City of El Paso – City Plan Commission Staff Report

Case No:	SUSU12-00101 Sunset Terrace Unit Four
Application Type:	Resubdivision Combination
CPC Hearing Date:	November 15, 2012
Staff Planner:	George Pinal, 915-541-4152, pinalg@elpasotexas.gov
Location:	West of I-10 and North of Borderland Road
Legal Description Acreage:	19.473 acres
Rep District:	1
Existing Use:	Vacant
Existing Zoning:	R-3A/sc and C-4/sc
Proposed Zoning:	N/A
Nearest School:	Jose H. Damian Elementary School (2.18 miles)
Nearest Park:	Proposed park (0.29-mile)
Parkland Fees Required:	$6,600.00
Impact Fee Area:	Westside Impact Fee Area – This development is subject to impact fees.
Property Owner:	Tropicana Development
Applicant:	CEA Group
Representative:	CEA Group

ATTACHMENT 3

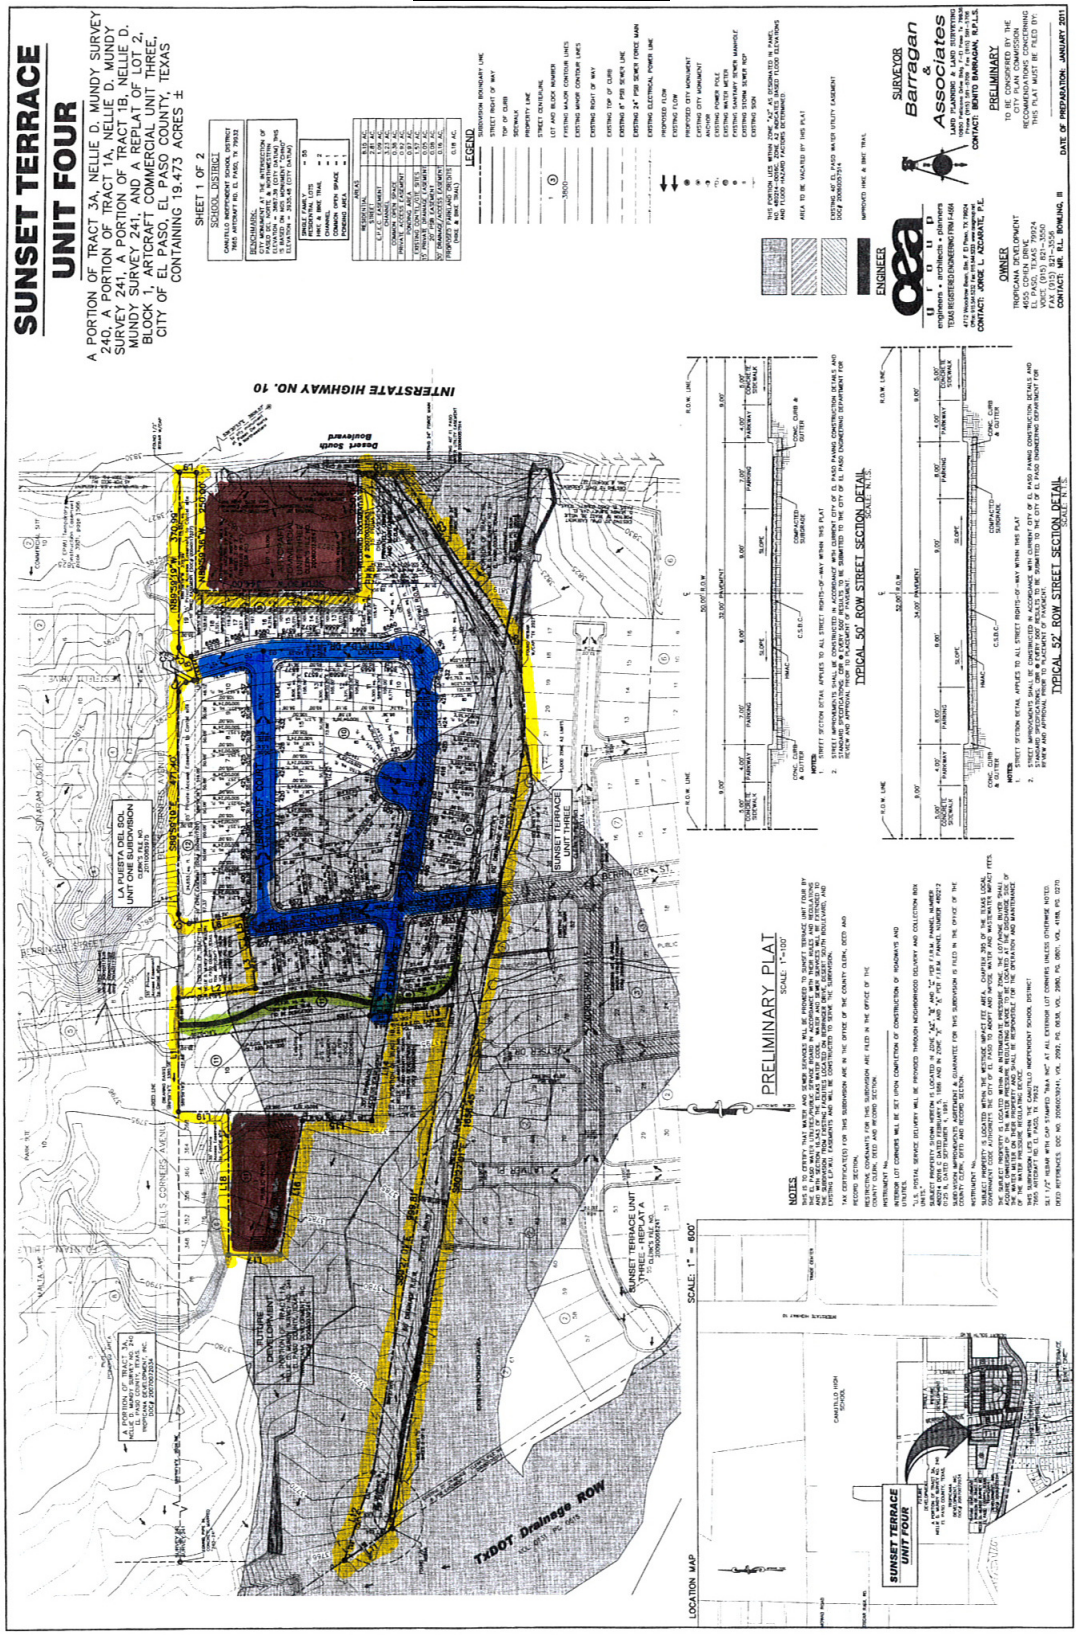
1. Sidewalks are required on TXDOT ROW.

The following comments are provided:
1. TXDOT approval is required for access and improvements to Desert Boulevard South.
2. Temporary breakaway guard posts with retro-reflective end of road markers or Type III barricades shall be required at the end of Bellwoode, Berringer, and Westfield.
3. All existing and/or proposed paths of travel (accessible sidewalks, wheelchair access curb ramps and driveways) within public rights-of-way shall follow the City of El Paso Design Standards for Construction and be ADA/TAS compliant.

EPWU Comments
Water:
4. There is an existing 60-inch diameter water transmission main located along Desert South Boulevard. No direct service meter connections are allowed to this 60-inch water main as per the El Paso Water Utilities-Public Service Board Rules and Regulations. The Owner/Developer shall minimize any grading above or near the existing 60-inch diameter water transmission main.

5. The subject property will be located within an intermediate pressure zone. Pressure reducing and pressure relief valves will be required within the water distribution system. In addition, private water pressure regulating devices will be required at the discharge side of each water meter. The Owner/Developer shall include in the sale of contract documents that the lot/home buyer shall acquire ownership of the above-described water pressure regulating devices to be located at the discharge side of the water meters. Additionally, the lot/home buyer shall be

Sanitary Sewer:
6. There is an existing 24-inch diameter sewer gravity force main along the existing 40-foot wide PSB easement/ROW. Also, there is an existing 8-inch diameter sanitary sewer main along the above mentioned 40-foot easement/ROW that starts just east of the western property line of Lot 11 and continues west along Bellwood Drive, then south along Berringer Road to connect to an existing main along Nordstrom Avenue.

General:
7. All easements dedicated for public water and sanitary sewer facilities shall comply with the EPWU-PSB Easement Policy. The PSB easements shall be improved to allow the operation of EPWU maintenance vehicles. EPWU-PSB requires access to the proposed sanitary sewer facilities within the easement 24 hours a day, seven (7) days a week.

Please note that this subdivision is composed of **57** (R-3A/sc) Single-family dwelling lots and applicant is proposing to dedicate an eleven feet (11') wide Hike/Bike trail for a total of **0.18 acres.**

Based on the following calculations, applicant shall be required to dedicate the **0.18 acres** of Hike/Bike Trail & pay park fees in the amount of **$6,600.00** in order to comply with the minimum parkland requirements:

1. Construction of the Hike & Bike trail shall be in accordance with the City of El Paso Park Design and Construction Standards as adopted by Council on June 03, 2008
2. Parks Department request that any “sloped areas” & 20' beyond each way be provided with the construction of a 24" high stem wall (from high side) to minimize erosion and wash-outs onto the trail.

Recommend for all areas beyond the proposed Hike/Bike trail to remain undisturbed.

ATTACHMENT 4

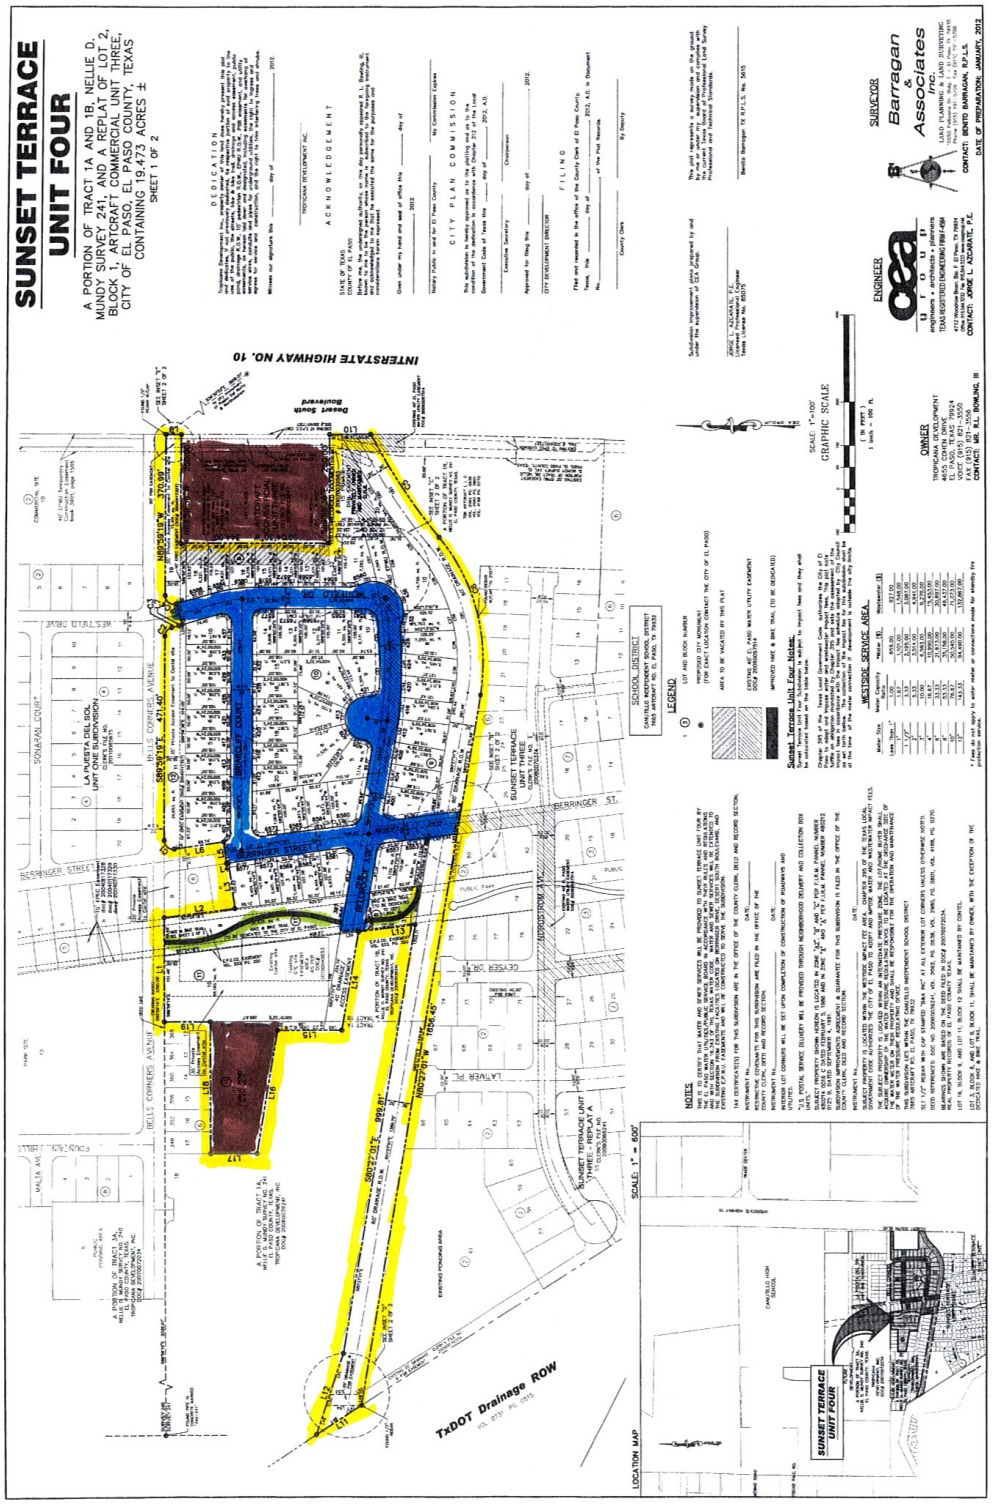
1. The subject property is located within the City of El Paso Westside Impact Fee Service Area. Impact fees will be assessed by the City of El Paso at the time of platting and collected by EPWU prior to the issuance of a Building Permit.

2. During the site improvement work, the Owner/Developer shall safeguard the existing water and sanitary sewer mains and appurtenant structures located within the subdivision. The Owner/Developer shall minimize changes in grade above or near the vicinity of the existing PSB facilities and is responsible for the costs of setting appurtenant structures to final grade.

3. The Owner/Developer has entered into a Development Agreement with the El Paso Water Utilities – Public Service Board (EPWU-PSB) to construct the proposed water and sanitary sewer mains to provide service to the subdivision. The Developer's utility contractor is installing the required water and sanitary sewer mains. These mains are not available for permanent service until EPWU-PSB issues a Letter of Final Acceptance of the facilities.
